Technical Update

Technical Update Brew Valve Exhausts

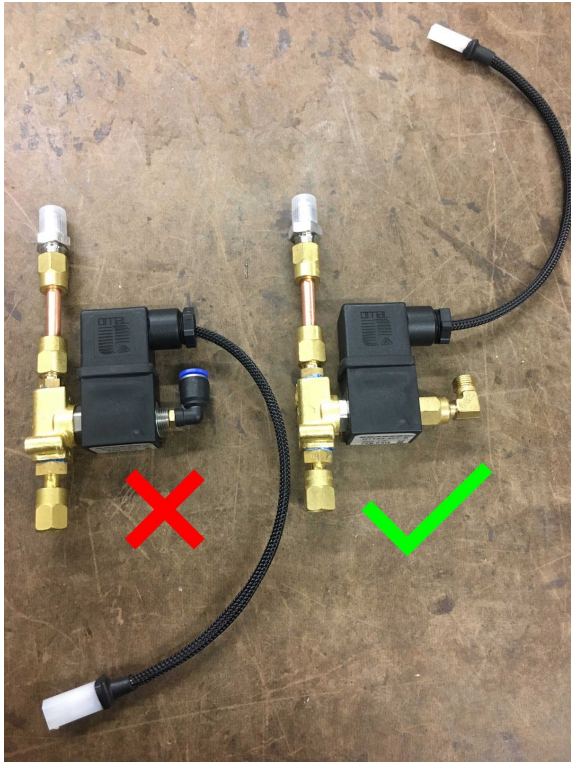
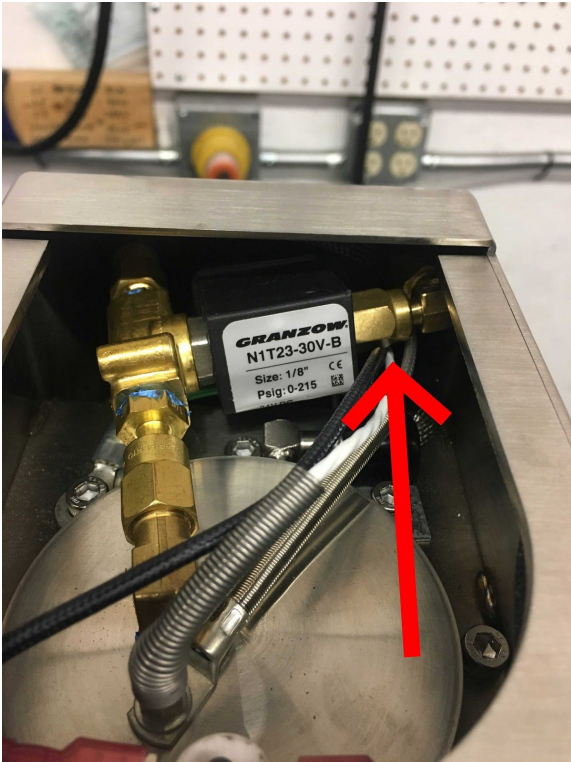
All Machines built before 2018 or any machine with non metal brew valve exhaust need to be updated. To check if you need updated brew valve exhausts please remove the top cover on the group tower with 3mm allen key (same tool used removing group screens)

Please review the photos shown to make sure you have the proper exhaust fitting to avoid leaks and component failure.

The update part number is MV-NEW-BREW-EXHAUST Please contact parts@mavamespresso.com or support@mavamespresso.com
